23 KIORA RD & 2-6 WILLOCK AVE

MIRANDA, NSW

COUNCIL RFI & RESPONSE

FEBRUARY 2024

SOLAR PLANES

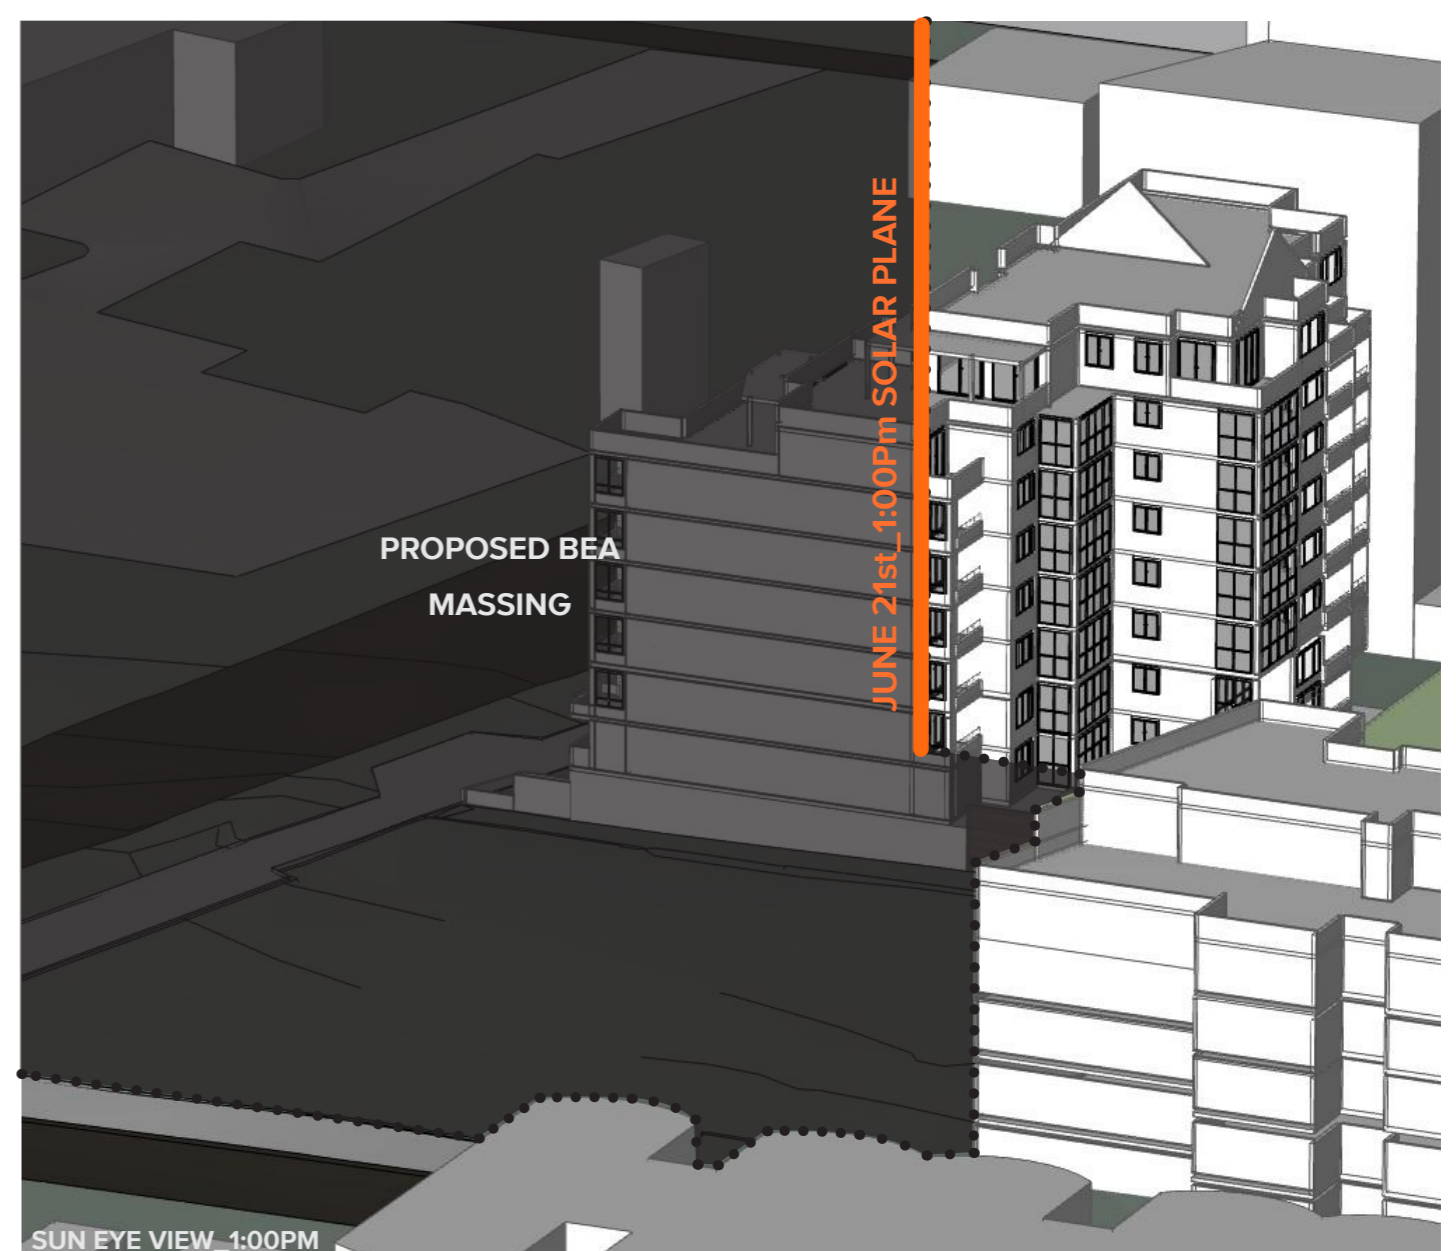
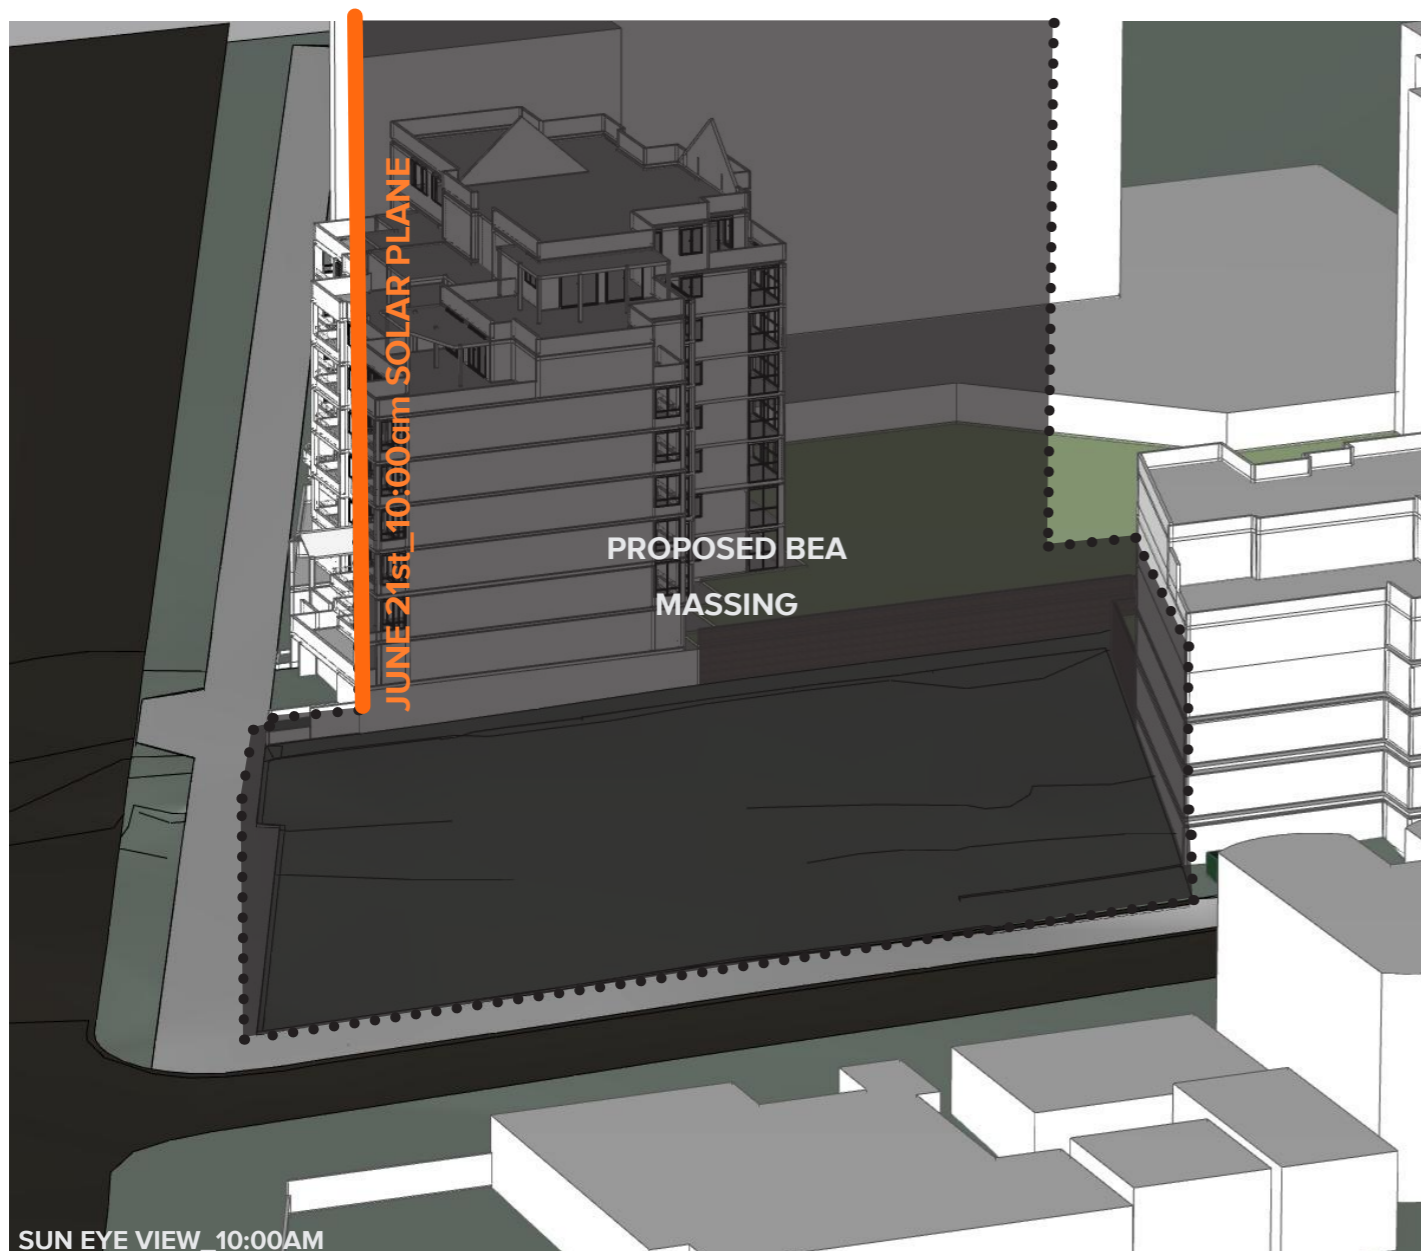
An overshadowing analysis has been provided indicating the impact on adjacent private communal open space and the primary school. However, a complete overshadowing analysis should include the impact on adjacent properties (windows), private open spaces, and shared open spaces. This would assist Council in conducting a holistic assessment of the planning proposal and impacts on adjoining properties.

The placement of the solar plane along the eastern boundary is determined by the angle at which the adjacent development begins casting a shadow on itself during the winter solstice (21st of June) at 10:00am. The apartments on the eastern facade of the adjacent development fail to meet the ADG minimum requirement of 2 hours of solar access.

The placement of the solar plane along the western boundary is determined by the angle at which the adjacent development begins meeting the ADG requirement of 2 hours of solar access, starting at 1:00pm on the winter solstice (21st of June). This ensures there are no overshadowing implications.

GROUND LEVEL INTERFACE

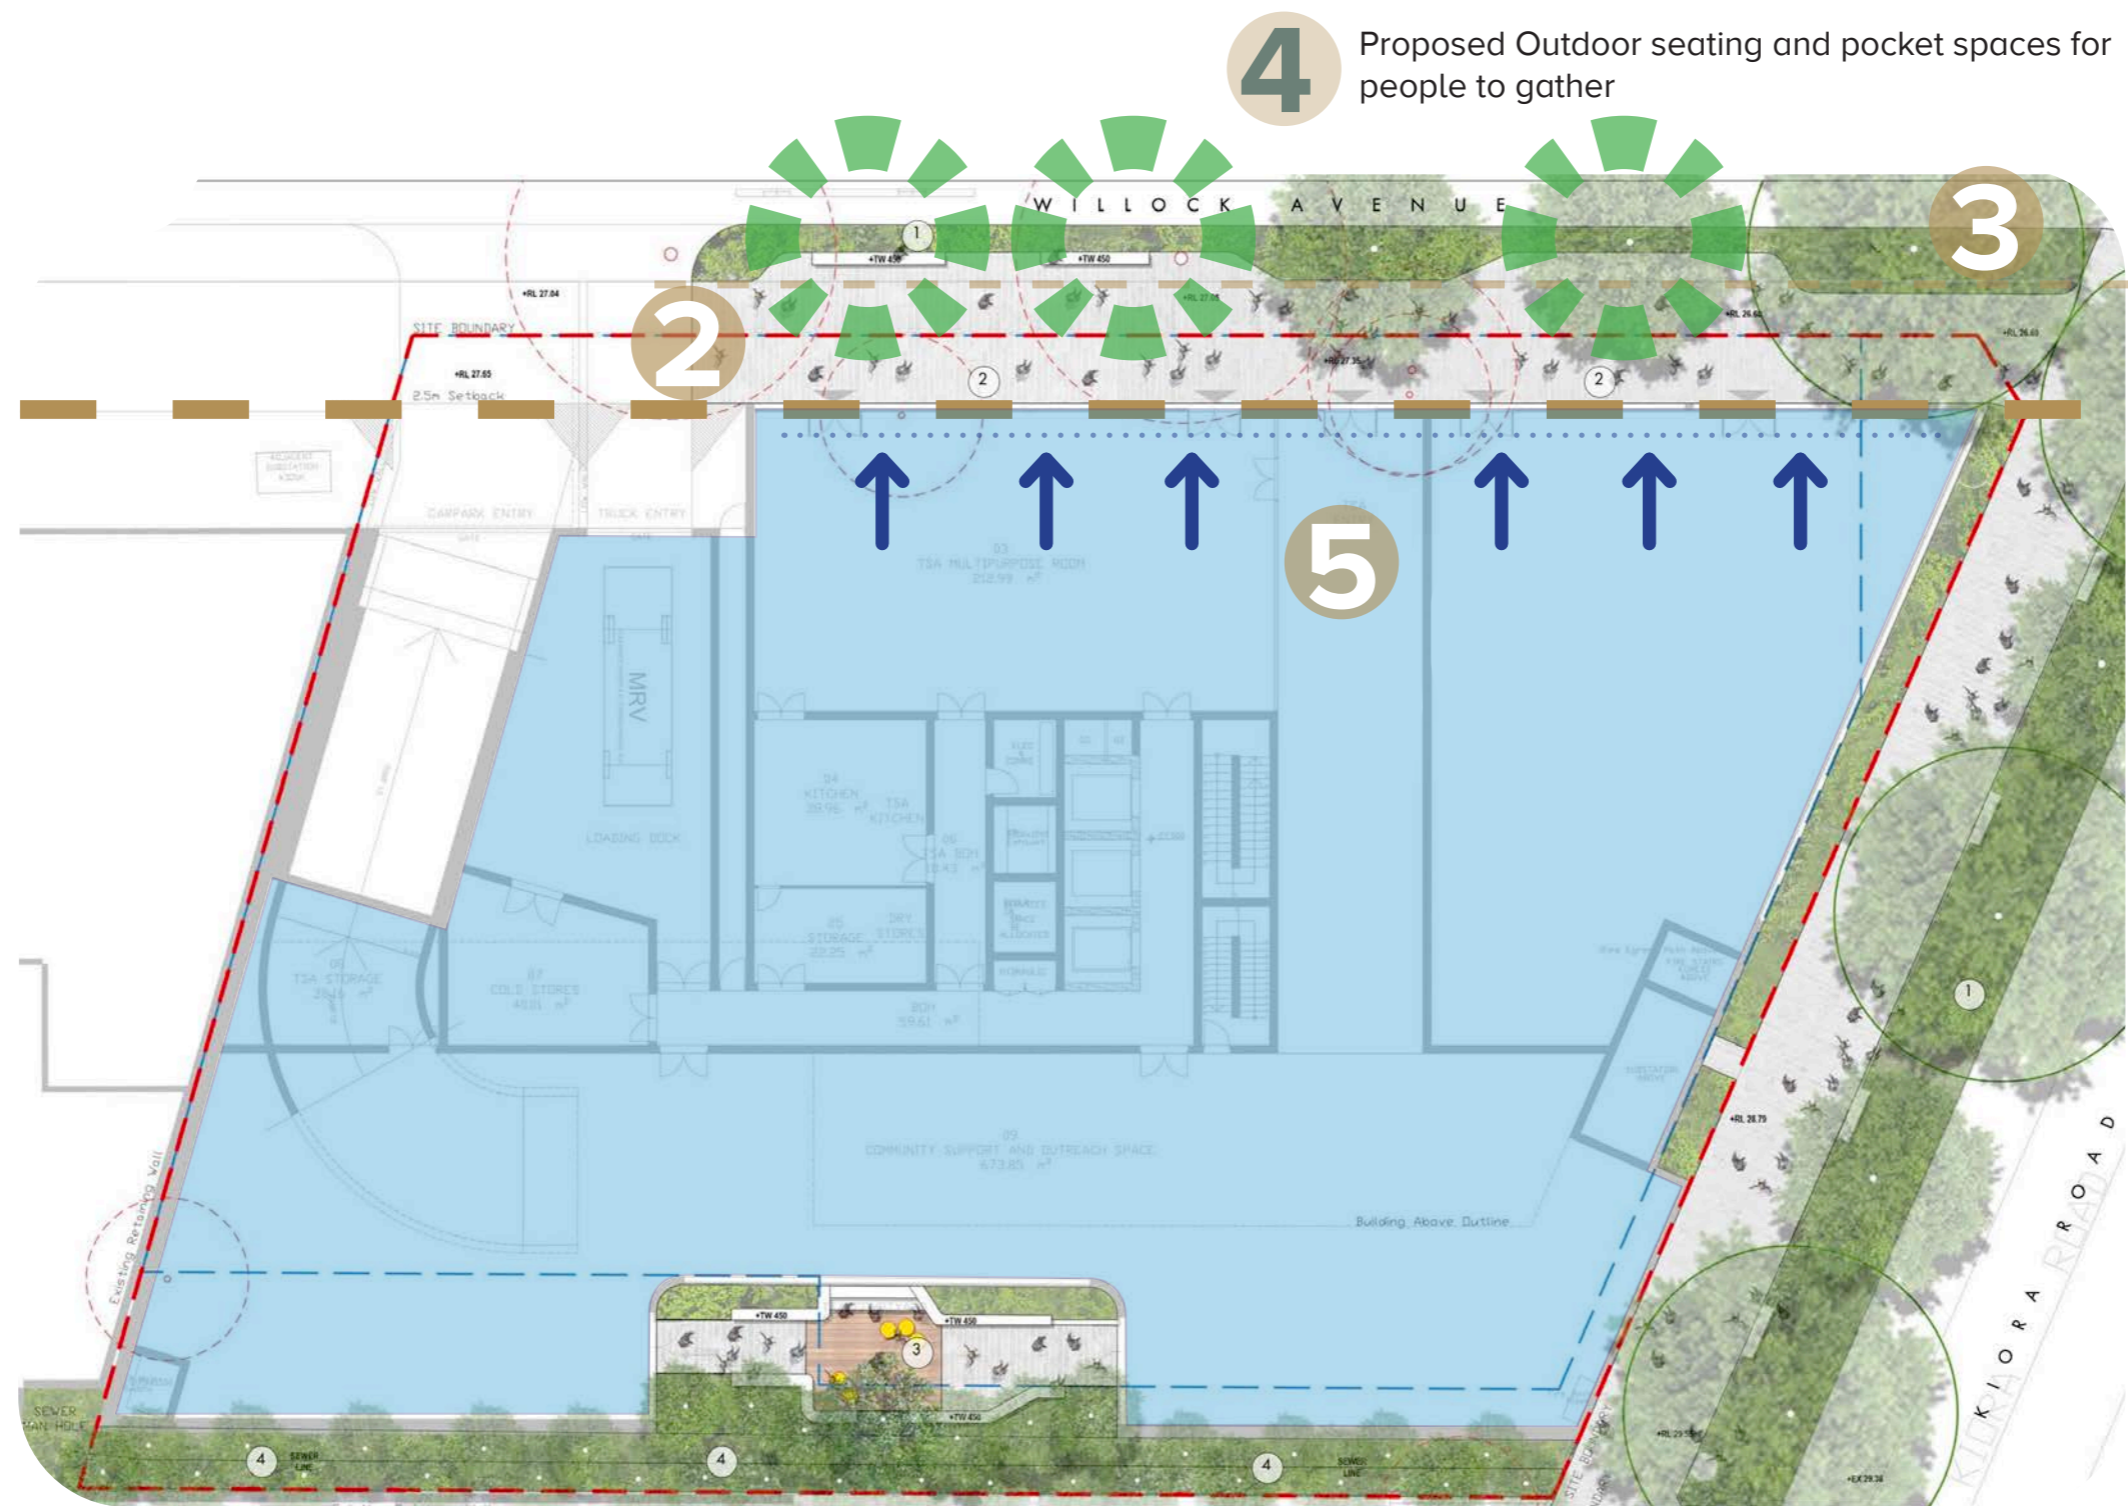
Safe and convenient pedestrian access should be facilitated along the southern side of Willock Avenue, where Council has consistently required the footpath width to be extended. This issue was raised with consultants Ethos Urban and McLaren Traffic, prior to the lodgement of the application, in August 2023. At present, the architectural drawings responds to requirement by providing a 2.5m setback on ground floor with overhead cantilever design on upper levels. The cantilever design does not enhance streetscape design on Willock Avenue. An increased setback on upper levels could affect floor space yield.

1
Ground Level Setback aligns with existing Willock Ave. street-scape

4 Proposed Outdoor seating and pocket spaces for people to gather

6 Spacious 4-meter-wide footpath
